From: Peres Da Costa, David
Sent: 09 September 2014 08:23
To: Planning
Subject: FW: Application 2014/4342/P - Air-conditioning Units at 1a Hawley Road

Comment against application to install x3 air-conditioning condensers to roof with a visual courtesy screen surround, Application Ref: 2014/4342/P

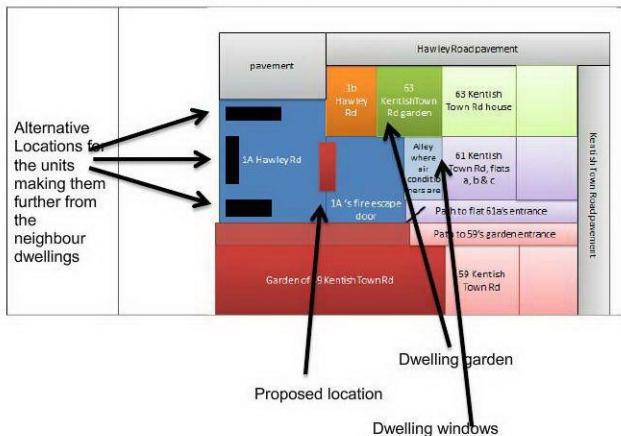
We are unclear from the proposal for the rationale for the proposed location of the units. From our perspective, the proposed location is the option most inconsiderate to the neighbours as it is the nearest to our dwellings. The units have already been installed which gives us direct experience on which to assess their impact. They create a large mass of approximately one metre in height and three metres in width, which means that our outlook becomes unacceptably closed in, which will be unchanged when surrounded by the proposed screen – see photo below.

It also raises concerns about the noise impact – see (2) below.
